PARKWAY CENTER SUBDIVISION

APPLICATION NUMBER 3 DATE May 5, 2022

REQUEST Subdivision

DETAIL SITE PLAN

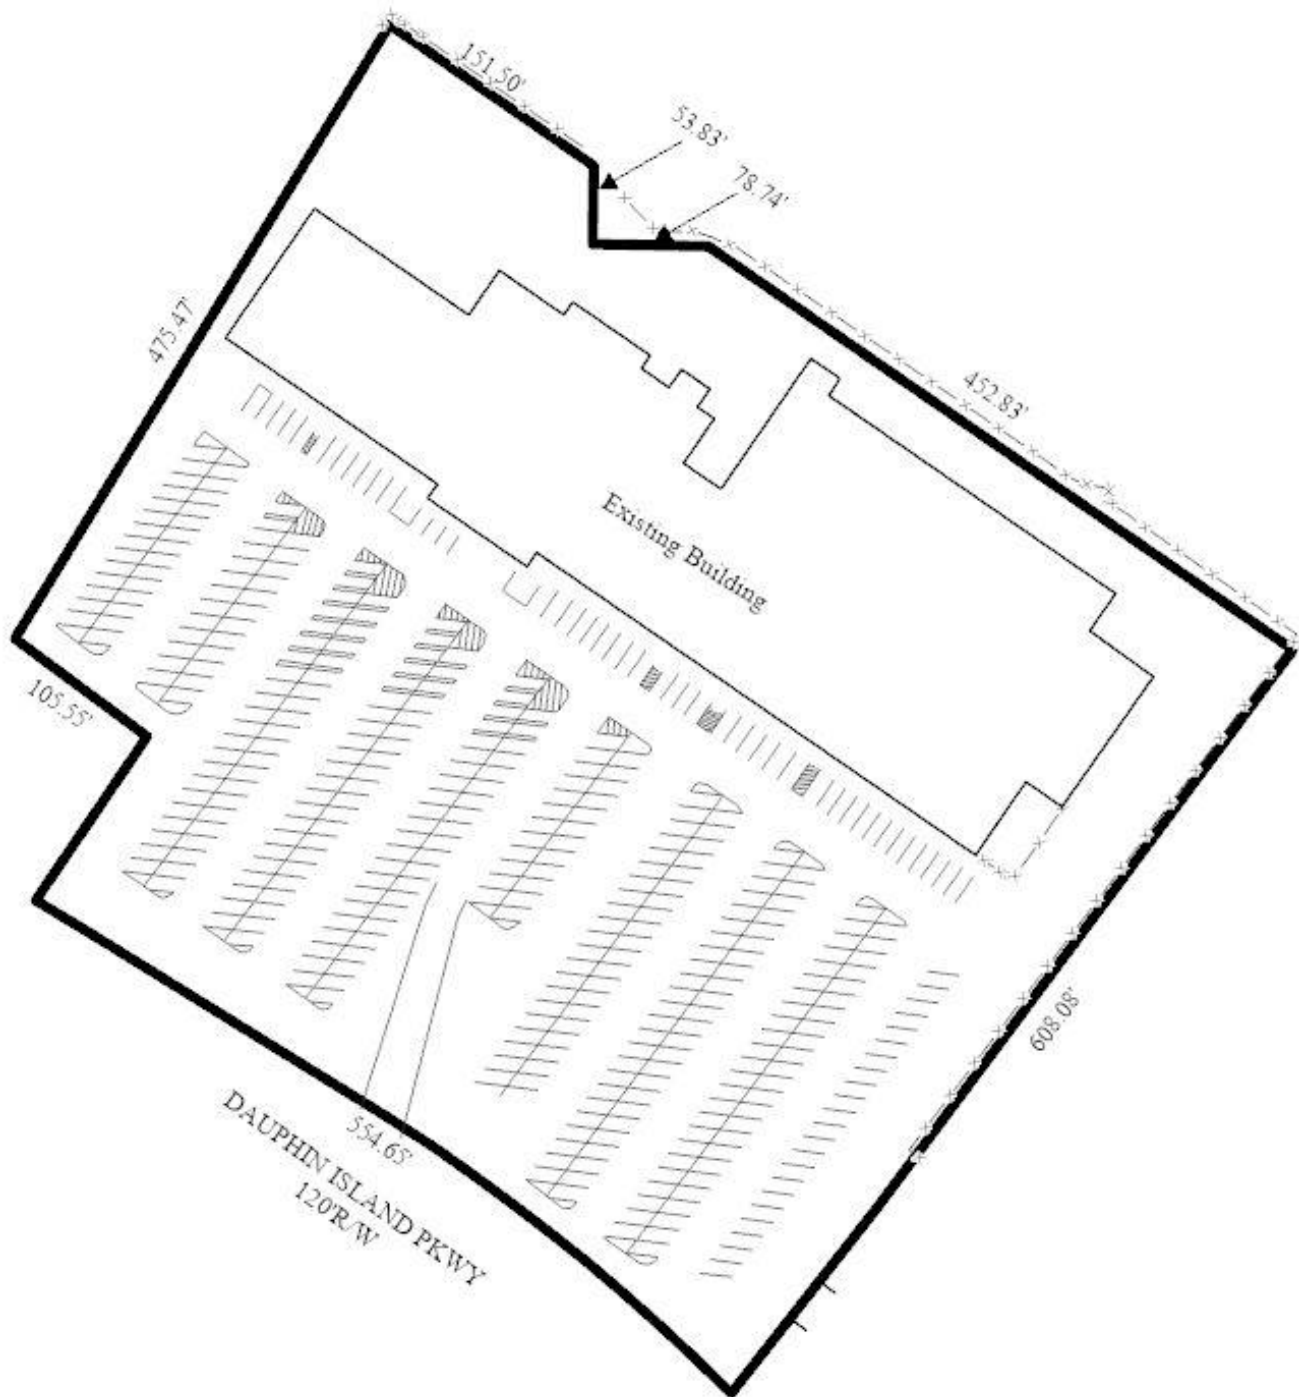
- B. Show and label the BFE (Base Flood Elevation) on each lot that contains an AE, V, or X (shaded) flood zone designation. The current FEMA FIRM lists the BFE at 11 feet.

The site has frontage on Dauphin Island Parkway, a component of the Major Street Plan with a planned 100-foot right-of-way. As the current right-of-way width is 120 feet, no dedication would be required. As on the preliminary plat, the right-of-way width of Dauphin Island Parkway should be retained on the Final Plat, if approved. The preliminary plat does not indicate the 25-foot minimum building setback line along Dauphin Island Parkway; therefore, the plat should be revised to indicate such, if approved.

The lot size label on the preliminary plat indicates the proposed lot meets the minimum size requirements of the Subdivision Regulations, and the lot size label in both square feet and acres should be retained on the Final Plat, or a table should be furnished on the Final Plat providing the same information.

No easements are indicated on the preliminary plat. If any easements exist or are proposed on the Final Plat, a note should be required on the Final Plat stating that no structure may be constructed or placed within any easement without the permission of the easement holder.

- 1) retention of the right-of-way width of Dauphin Island Parkway on the Final Plat;
- 2) revision of the plat to indicate a 25-foot minimum building setback line along Dauphin Island Parkway;

- 3) retention of the lot size label in both square feet and acres on the Final Plat, or the furnishing of a table on the Final Plat providing the same information;

- 4) placement of a note on the Final Plat stating that no structure may be constructed or placed within any easement without the permission of the easement holder;
